Planning and Zoning Commission

February 5, 2019

Dallas Center – Grimes Middle School – Site Plan

FOX Engineering has completed the second review for the DC-G Middle School Site Plan dated January 29, 2019. Please address the following comments:

Landscape Plans – Sheet C-500 to Sheet C-505

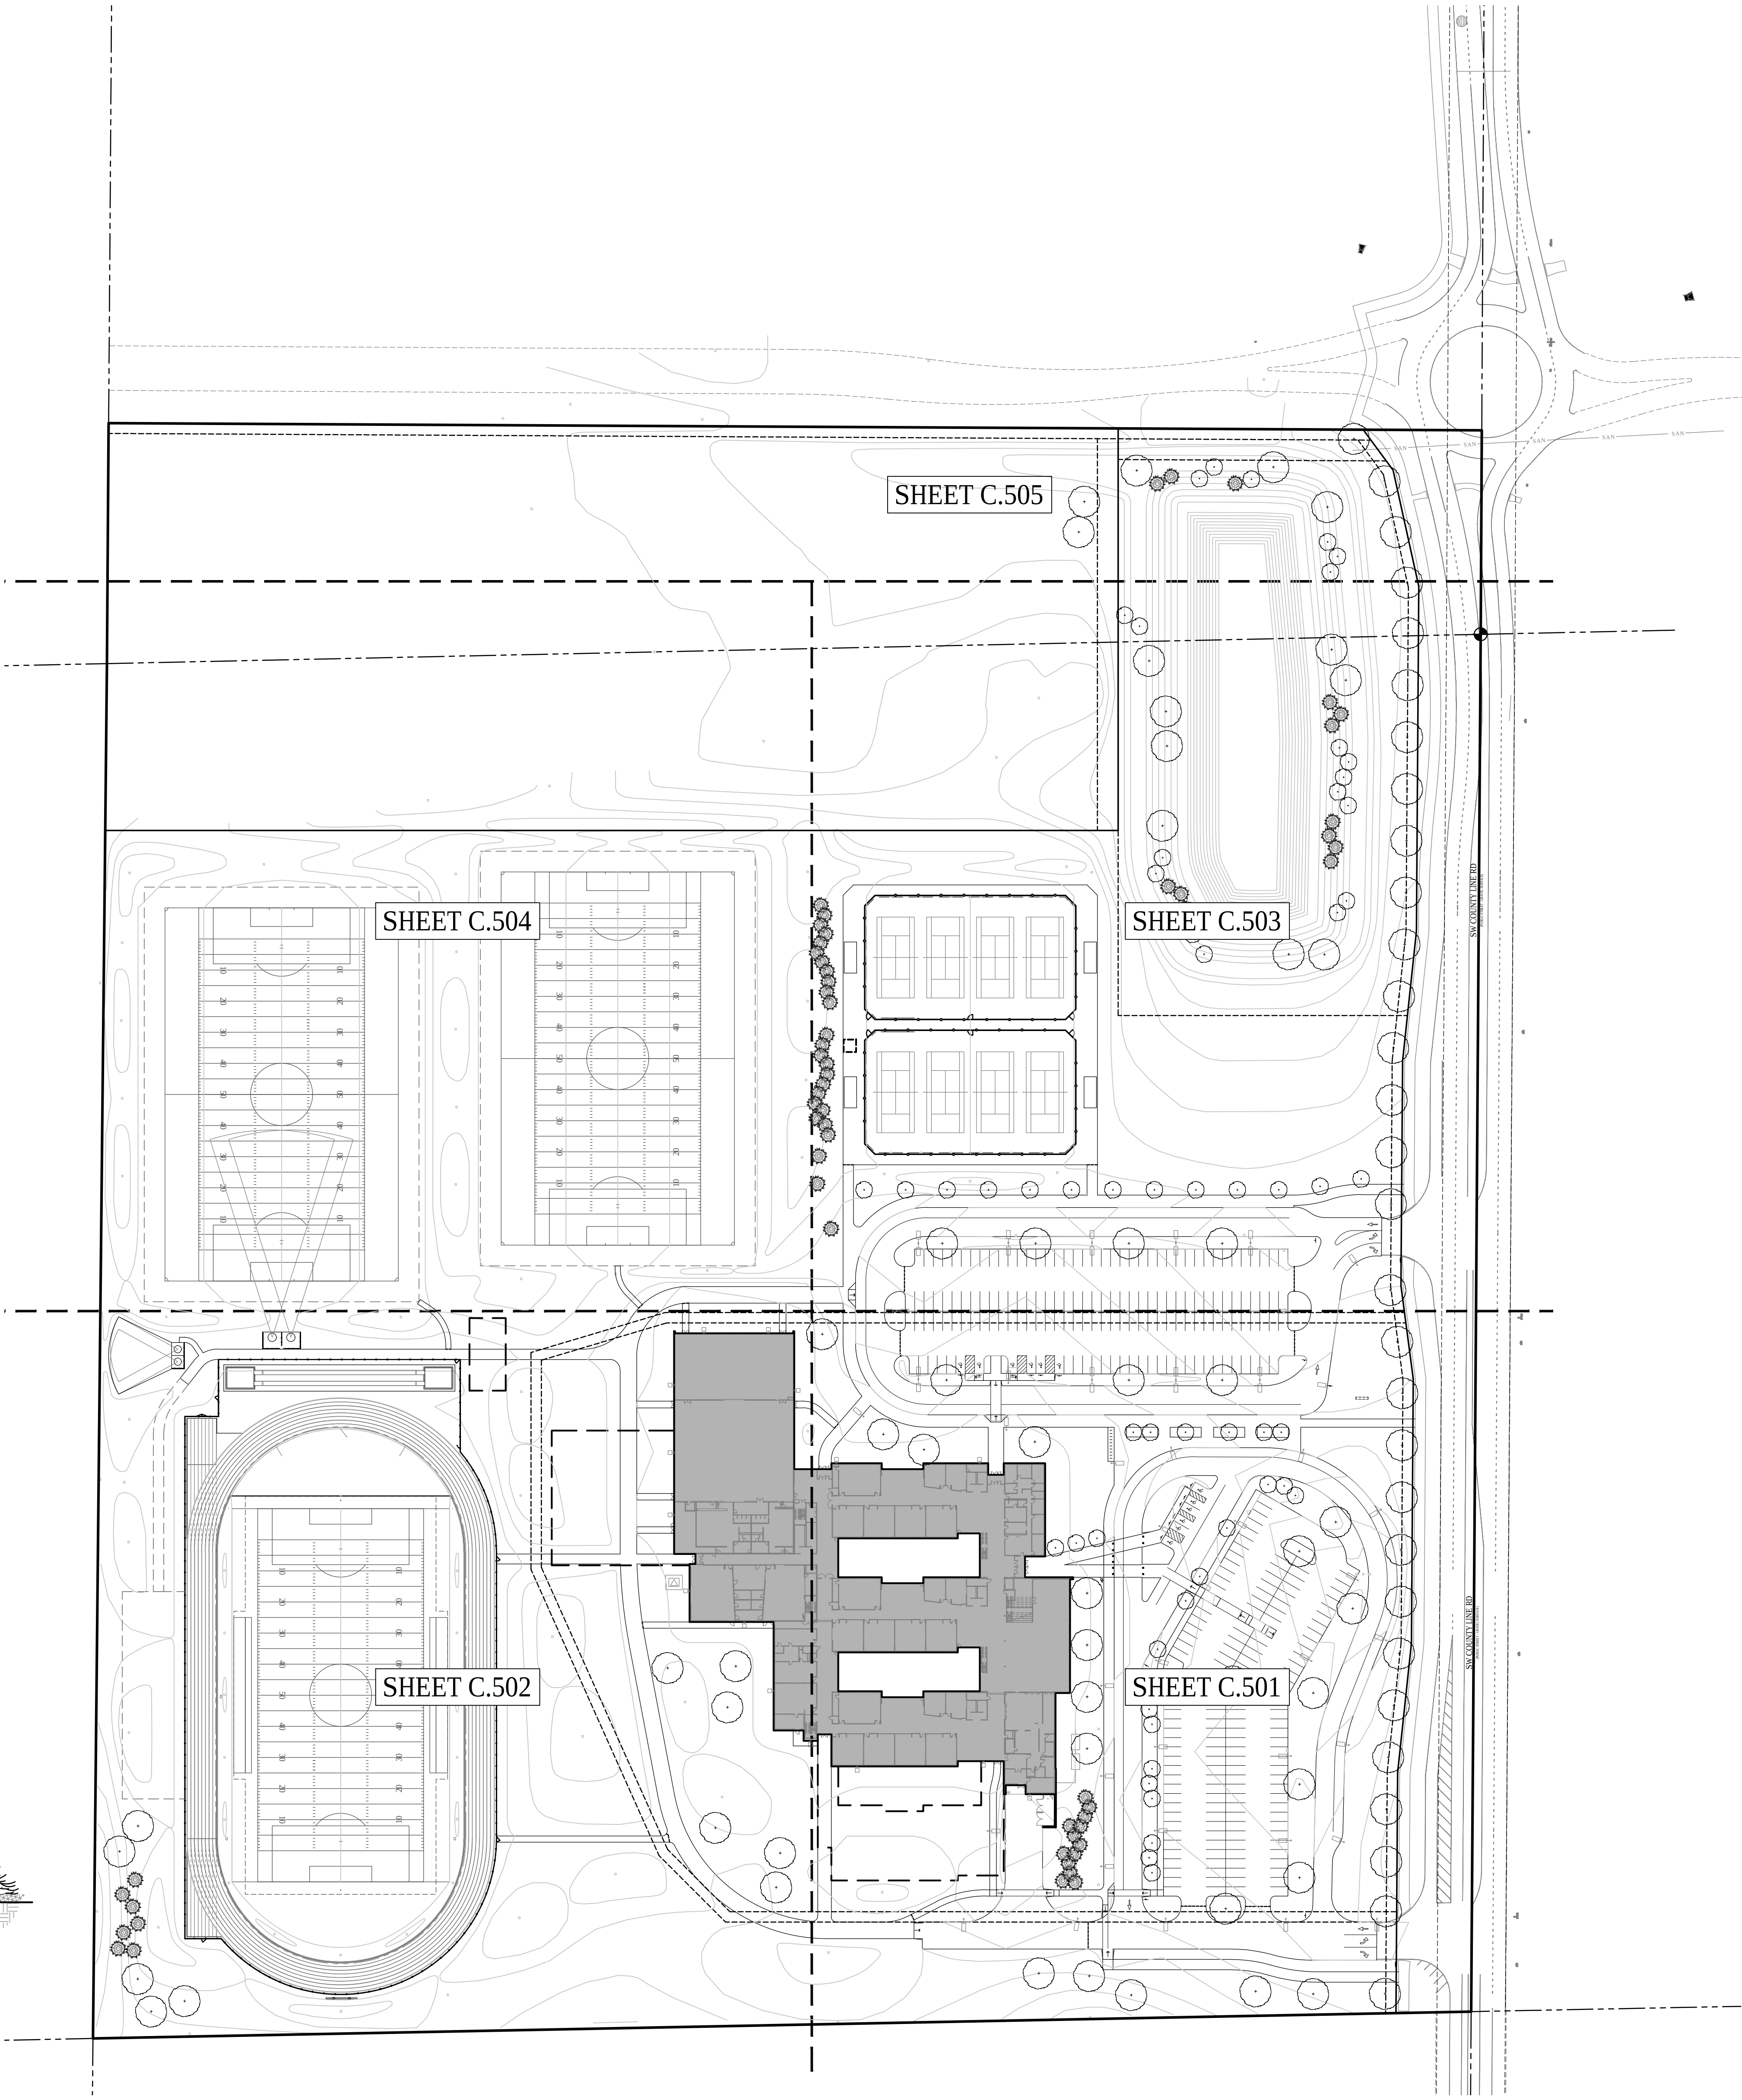
9. P&Z and Council will need to review and provide input regarding the landscape plan. Please consider planting more shrubs or ornamental grasses within all parking lot islands.

Architectural/Elevation Plans

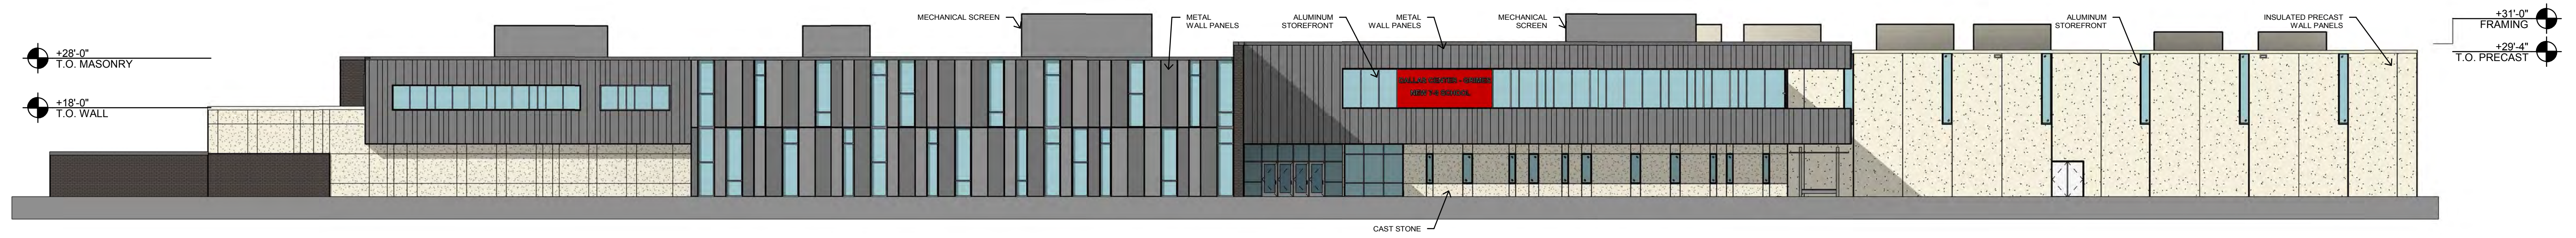
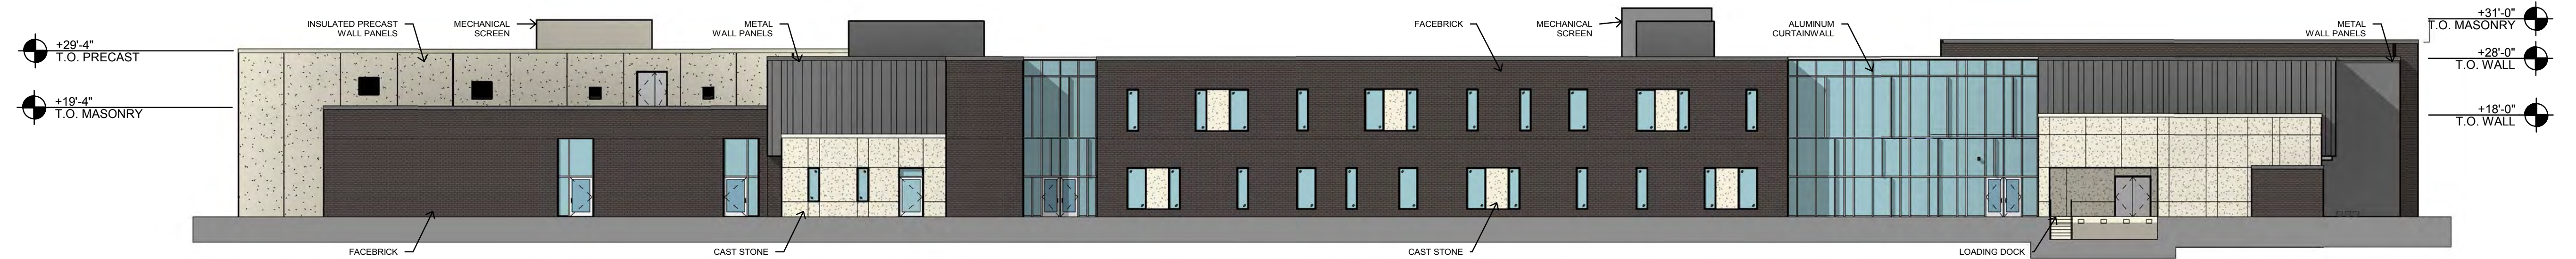
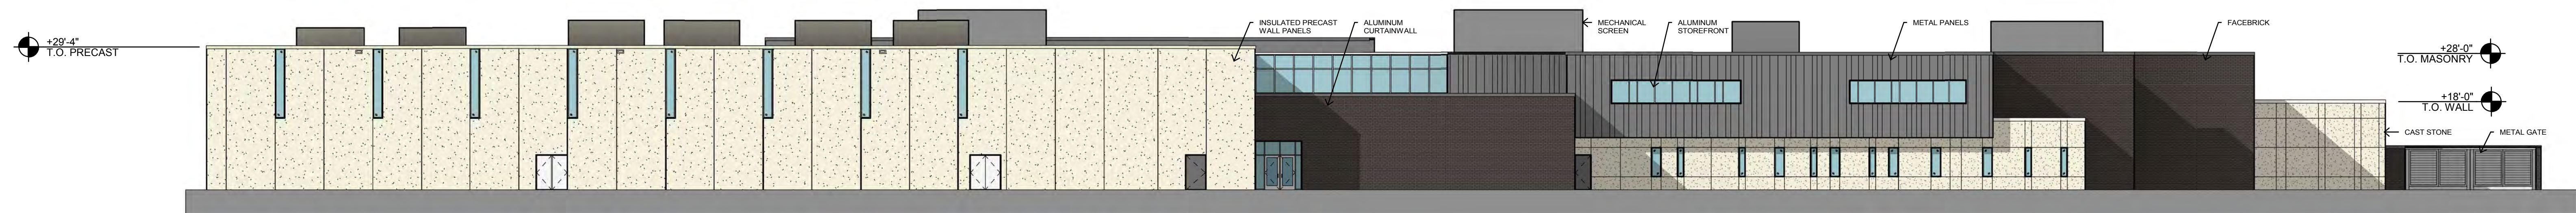
- 25. Please provide an elevation plan that shows dimensions (horizontal) of the structure as well as colors for the proposed materials.
- 26. Please provide labels to clarify that there are reveals between precast concrete panels to break up and add interest to the expanse of the large precast walls as you've stated.
- 27. It is highly recommended that you bring building materials to P&Z for discussion.
